Salado ISD Bond

Advisory Committee

January 22, 2024

BOND COMMITTEE Q&A

OVERALL SITE PLAN

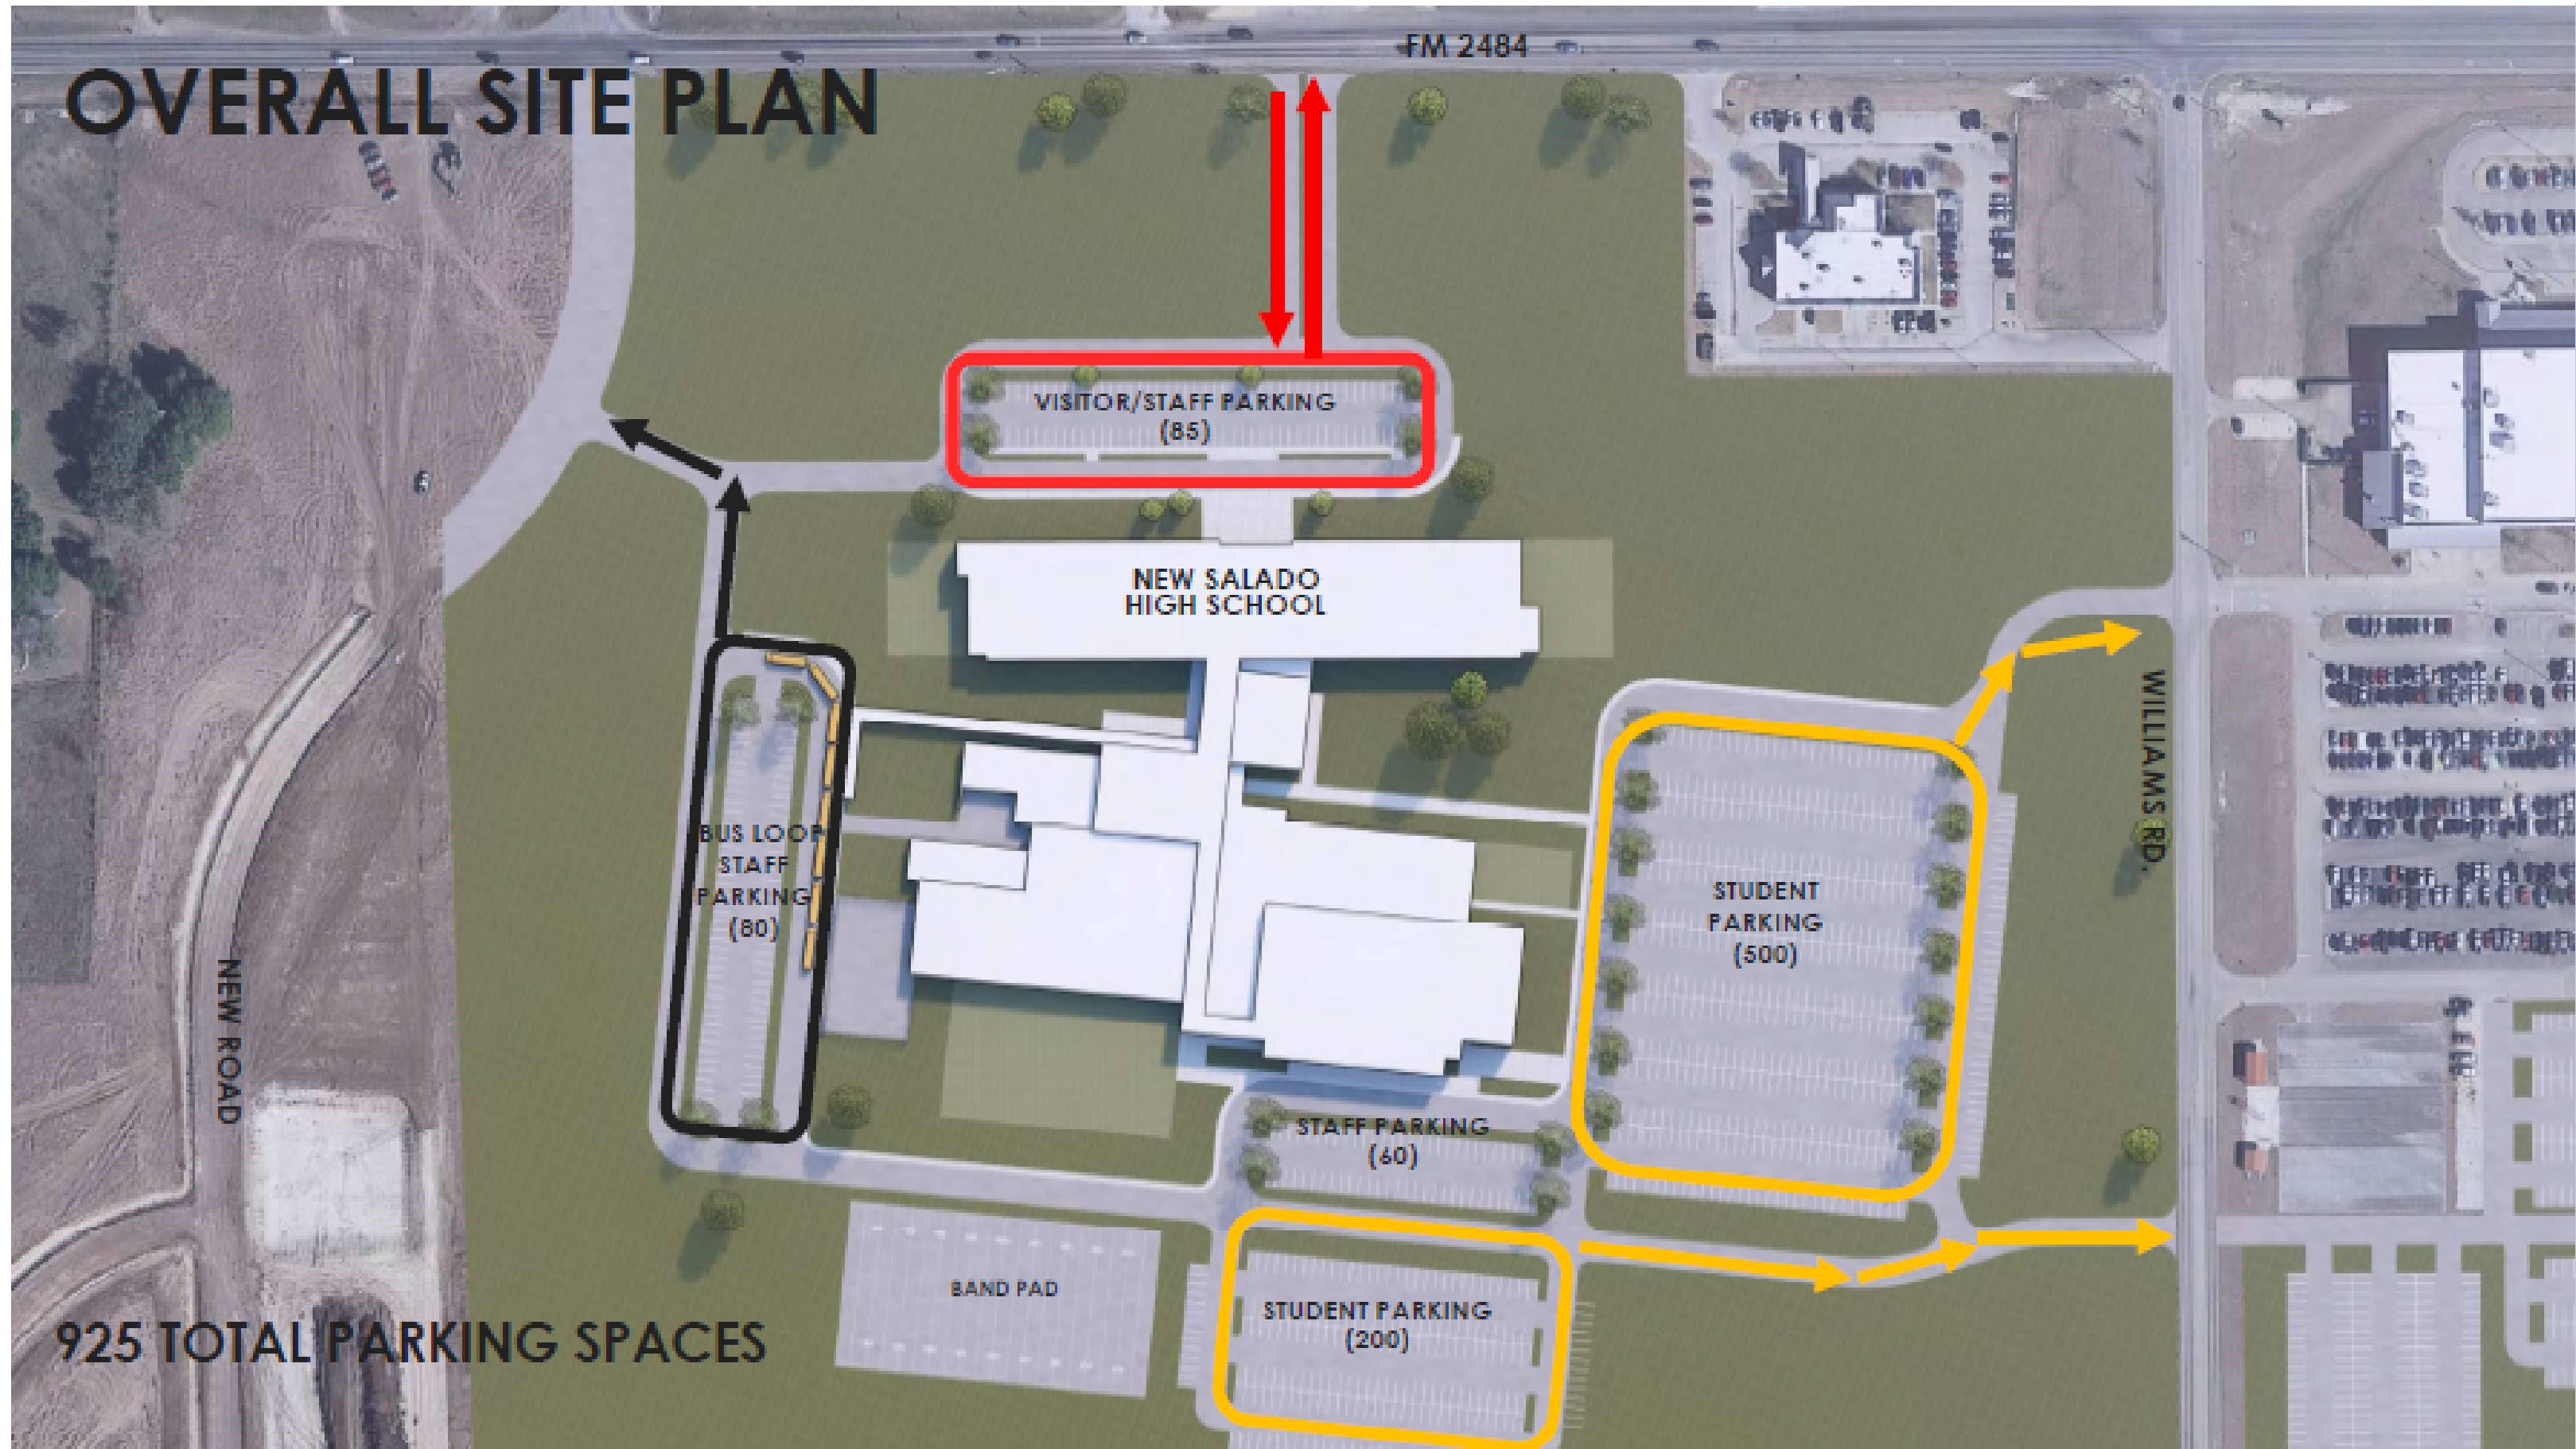
Does the plan accommodate future expansion?

Will there be access from the high school site to the future neighborhood to the south?

Does the total parking count shown include all student, staff, and visitor parking?

Why divide the proposed future classroom additions into two locations?

The site and building plan include space for future classroom additions and a future auditorium addition.

This is not currently included but will be considered.

Yes.

The plans show potential locations for two classroom additions. The exact layout can be determined when the need for those additions arise.
